# DEVELOPMENT REVIEW COMMITTEE (DRC) COMMENT REPORT

**PROJECT NAME:** Marina Landings

CASE NUMBER: UDP-S21033

REQUEST: Site Plan Level III Review: Zero Lot Line Development

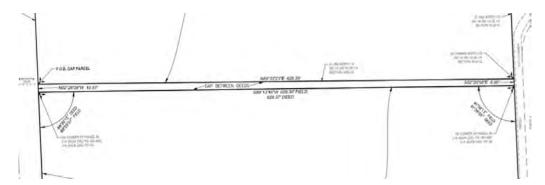
- e. Relocation of Building 16 away from drainage retention area;
